# UNITED STATES PATENT AND TRADEMARK OFFICE

APPLICATION NO.	FILING DATE	FIRST NAMED INVENTOR	ATTORNEY DOCKET NO.	CONFIRMATION NO.
09/887,877	06/21/2001	Donald Brian Eidson	01827.0037.CPUS01	9000

## Office Action Summary

## **DETAILED ACTION**

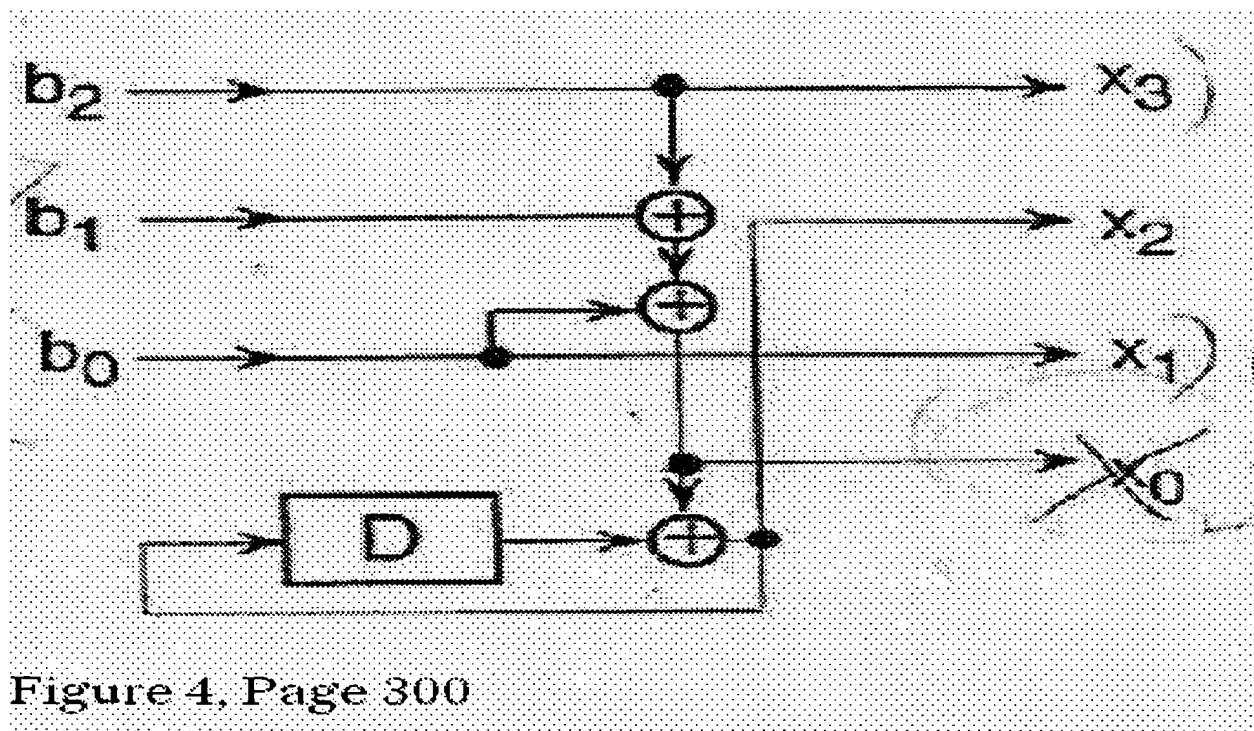
As per claims 1 and 54, Benedetto et al. (herein after: Benedetto) substantially teaches the limitations in claims 1 and 54 of the present application through Figure 3, page 295; Figure 4, page 300 and Figure 8, page 339. For example, Claim 1 of the present application recites: A rate  $n/n$  recursive, systematic convolutional encoder which comprises:  $n$  inputs, wherein  $n$  is an integer greater than 1;  $n$  parallel outputs; an adder having  $(n+1)$  inputs and an output; and a feedback loop, including one or more storage elements in series, coupled to the output of the adder and to an input thereof, the feedback loop and the one or more storage elements being characterized by a prime polynomial; wherein all  $n$  encoder inputs are input to the adder,  $(n-1)$  of the encoder inputs are passed through unaltered to form  $(n-1)$  of the encoder outputs, and the  $n^{\text{th}}$  encoder output is derived from the feedback loop. The following figure is imported from Benedetto's reference.

The Examiner would like to point out that in the above Figure 4, Benedetto teaches the limitations of claim 1 with slight modification. The following description is in reference to Figure 4 above: The adder connected to the output of the delay element has  $(n+1)$  inputs, which are  $b_2$ ,  $b_1$ ,  $b_0$  and the output of the adder. The output of the adder is formed in a feedback loop that includes a storage element. Furthermore, two of the three inputs of the encoder are unaltered, namely  $b_2$  and  $b_0$ , whose respective outputs are  $x_3$  and  $x_1$ .

Benedetto does not explicitly teach a rate  $n/n$  encoder as stated in the present application. The Examiner would like to point out that it is well known in the art that a rate of an encoder is defined as the ratio of the number of inputs to outputs. The limitation of claim 1 of the present application states a rate  $n/n$ , which essentially means that the number of inputs is equal to the number of outputs. Referring to Benedetto's Figure 4 above, one of ordinary skill in the art at the time the invention was made would have recognized that by eliminating output  $x_0$  would indeed have made the above-shown encoder a rate  $n/n$ . This modification would have been obvious to one of ordinary skill in the art because one of ordinary skill in the art would have recognized that by eliminating the  $x_0$  output of the encoder taught by Benedetto in Figure 4 would have increased the coding gain at relatively low bit error rates. Furthermore, the Examiner would like to add that by removing the  $x_0$  output also would have been an obvious design choice and not patentably distinct.

As per claims 2-3, Benedetto substantially teaches, in view of above rejections and Figure 4 above, a feedback loop that includes a single storage element wherein the input of the storage element is coupled to the output of the adder, and the output of the storage element is
